ZONING BOARD OF REVIEW MEETING
Jamestown Town Hall
Rosamond A. Tefft Council Chambers
93 Narragansett Avenue
Tuesday, July 28, 2020
7:00 PM

TO: Jamestown Zoning Board of Review
FROM: Lisa Bryer, AICP, Town Planner
RE: Motion for Zoning Section 82-314: High Groundwater Table and Impervious Overlay District, Sub-District A – Gail and David Stokes: AP 16, Lot 85; 86 Frigate Street, Jamestown, RI
DATE: June 18, 2020

TO: Jamestown Zoning Board of Review
FROM: Lisa Bryer, AICP, Town Planner
RE: Motion for Zoning Section 82-314: High Groundwater Table and Impervious Overlay District, Sub-District A – Andrew Bilodeau: AP 5, Lot 164; Beach Avenue, Jamestown, RI
DATE: June 10, 2020

SITE PLAN
 for
AP 16 LOT 85
86 FRIGATE STREET
 in
JAMESTOWN, RHODE ISLAND

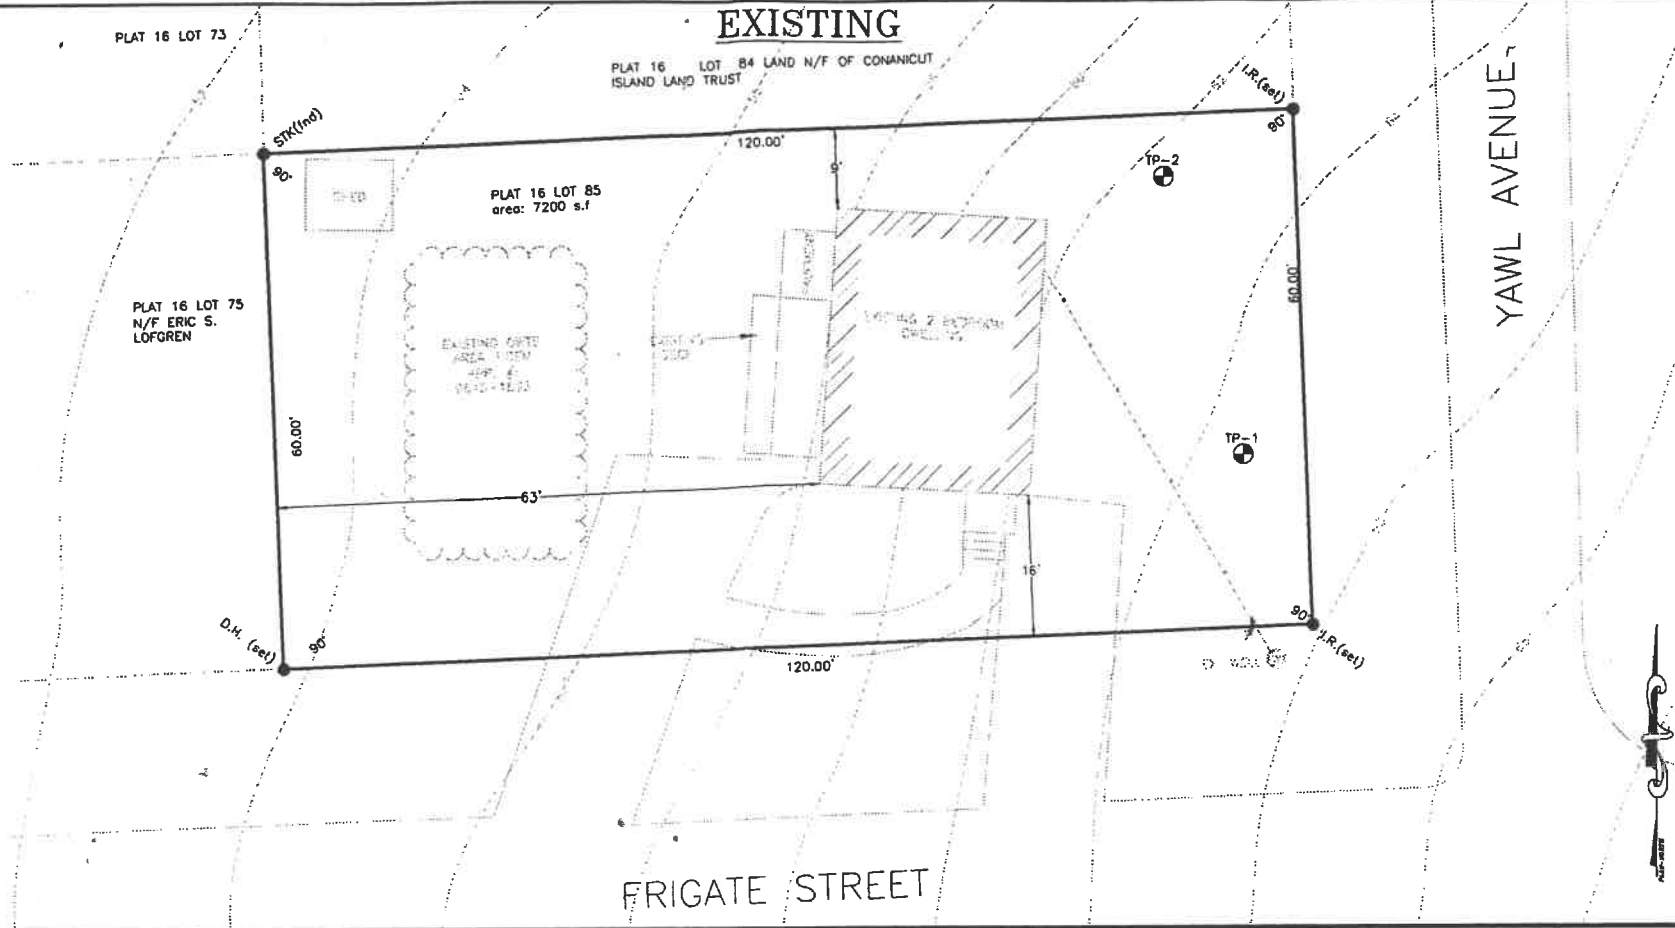
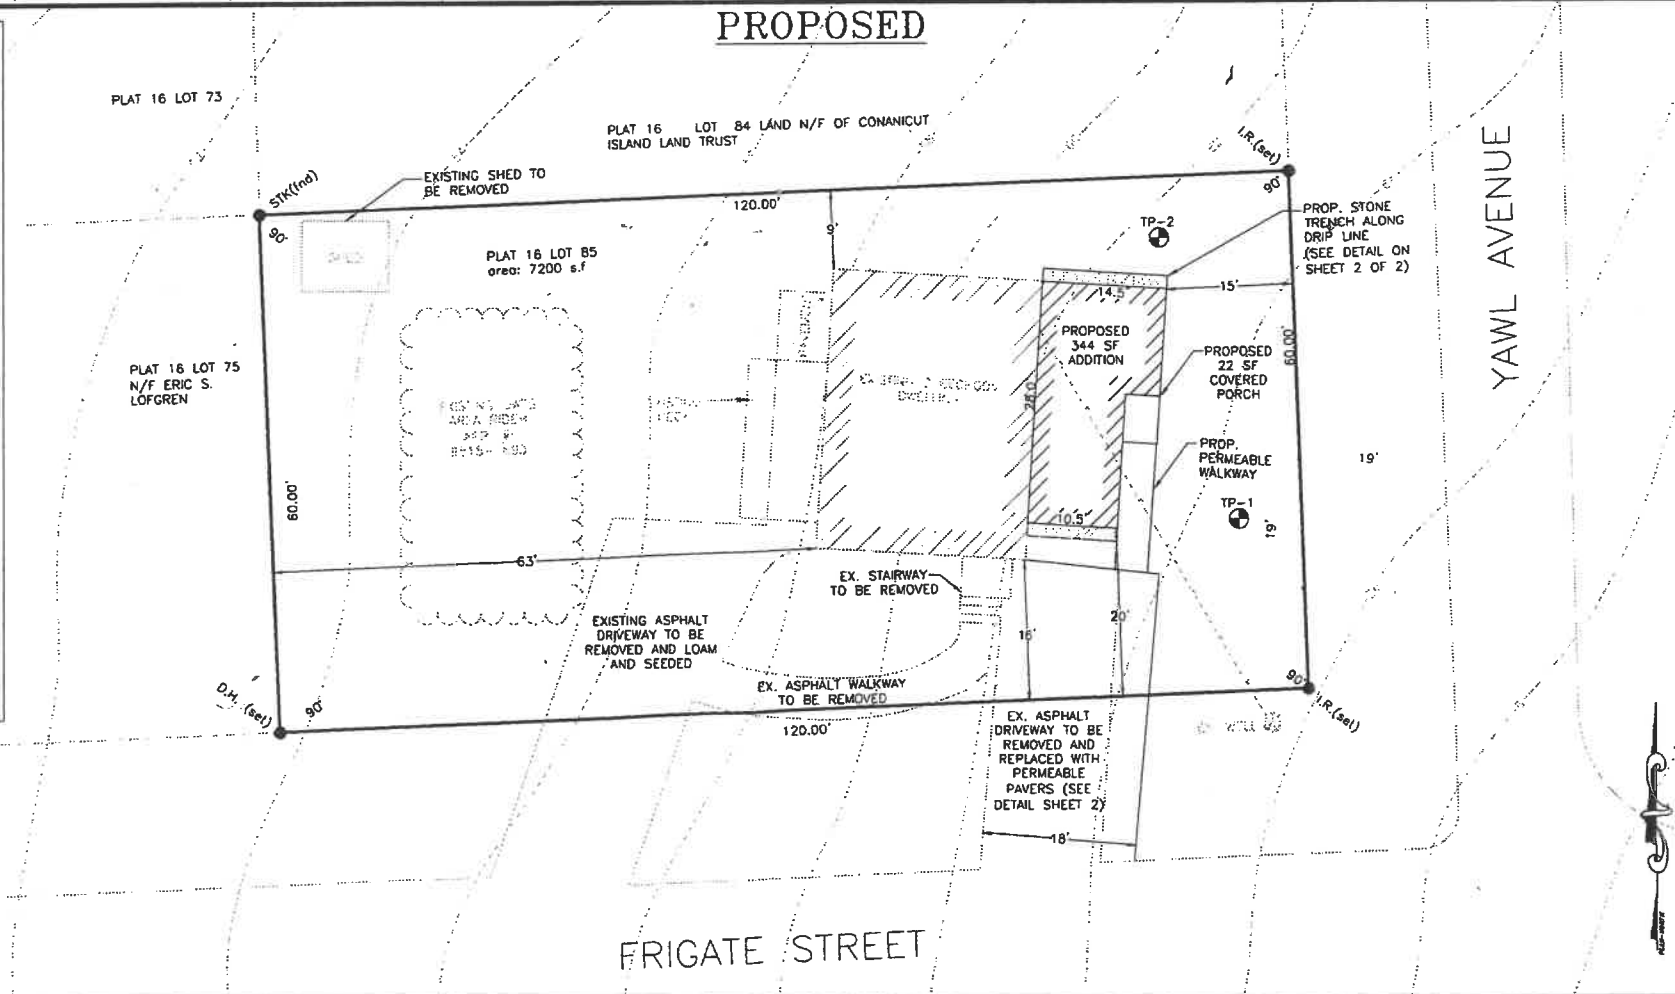
17. Jamestown Engineer Jean Lambert provided correspondence to Chris Costa, Building Official and Lisa Bryer, Town Planner dated June 10, 2020 regarding the Stokes application (attached). As noted above, the proposed project exceeds the allowable area of impervious cover; and

I have reviewed the site plan entitled, "Site Plan for AP 16 Lot 85, 86 Frigate Street in Jamestown RI" revision dated 5/14/2020, prepared by Principe Company, Inc. for the above referenced property.

Two stone infiltration trenches are proposed to provide water quality treatment of new rooftop runoff. The required stormwater treatment volume for the new rooftops is 30.5 cubic feet (cf) and 75 cf are provided. The proposed BMP provides treatment for the 1" water quality volume for the new impervious surfaces on the site.

5. An as-built plan shall be provided at the completion of construction to the Building Official depicting the size and location of the house, size and location of the rain gardens, and verifying the elevations and grading shown on the proposed site plan;

6. The OWTS must be inspected and maintained as required by the Town Onsite Wastewater Management Program. A maintenance contract must be recorded in the land evidence records and a copy of the recorded document shall be submitted to the Planning Department; and,

7. The Operation and Maintenance (O & M) Plan (reproduced in 8.5" x 11" for the stormwater mitigation (rain gardens) shall be recorded in the Office of the Town Clerk with the Zoning Approval and evidence of such shall be provided to the Zoning Enforcement Officer as well as the Planning Department.
8. An erosion and sediment control permit will be required from the building official prior to commencement of construction. Erosion and sediment controls shall be installed at the down gradient limit of disturbance as shown on the site plans. Erosion controls shall be maintained until final stabilization is achieved on the site.
9. Any additional future site work that increases the area of impervious coverage will require a review following the requirements of the High Groundwater Ordinance

DEVELOPMENT PLAN
BEACH AVE PLAT 5 LOT 164
JAMESTOWN, RI

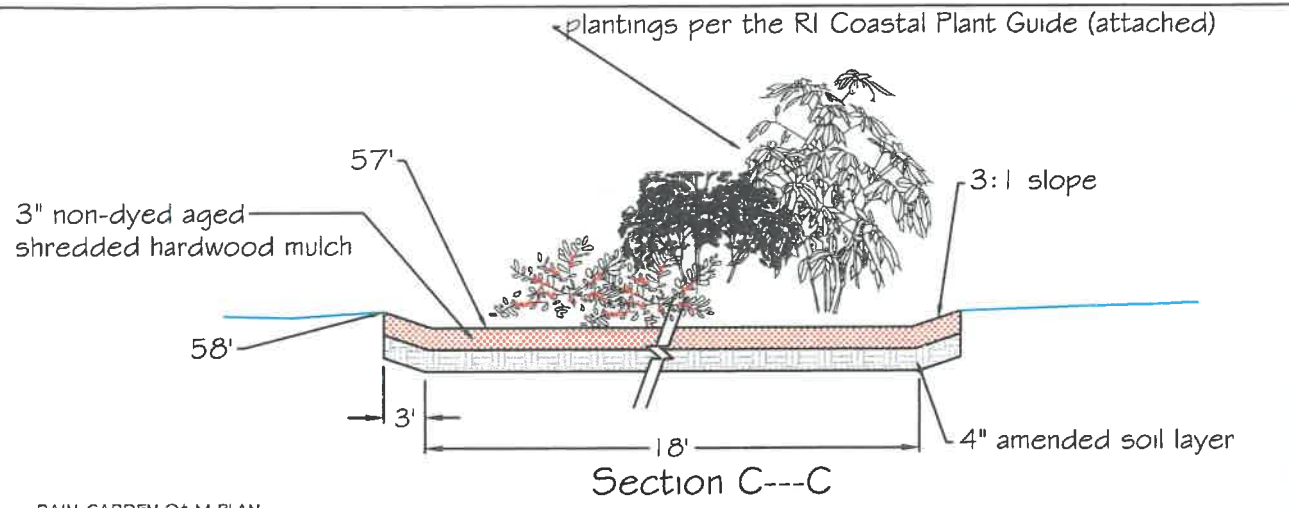
I have reviewed the site plan entitled, “Development Plan, Beach Ave, Plat 5 Lot 164, Jamestown RI” revision dated 2/14/2020 and prepared by RP Engineering, Inc. for the above referenced property. **In my professional judgement, the requirements for development within 82-314 Sub-District A have been met.** This site was previously reviewed and approved under the HGWT process in 2012.

The proposed impervious cover is 9.8%, 1530 sf. The maximum allowable impervious coverage for this site is 1556 sf. The proposed BMP’s provide treatment for the 1” water quality volume and provide storage for runoff from a 10-year frequency storm event for the proposed impervious surface on the site.

3. An as-built plan should be provided at the completion of construction to the Building Official depicting the size and location of the house, size and location of the rain gardens, and verifying the elevations and grading shown on the proposed site plan;

6. An erosion and sediment control permit will be required from the building official prior to commencement of construction. Erosion and sediment controls shall be installed at the down gradient limit of disturbance as shown on the site plans. Erosion controls shall be maintained until final stabilization is achieved on the site.

- Rain garden maintenance requirements shall be recorded into the land evidence record.
- The proposed rain garden area shall be physically delineated on the site prior to the commencement of construction to prevent compaction of the soil.
- Erosion and sediment controls shall be installed at the downgradient limits of site disturbance as shown on the site plan prior to the commencement of construction.
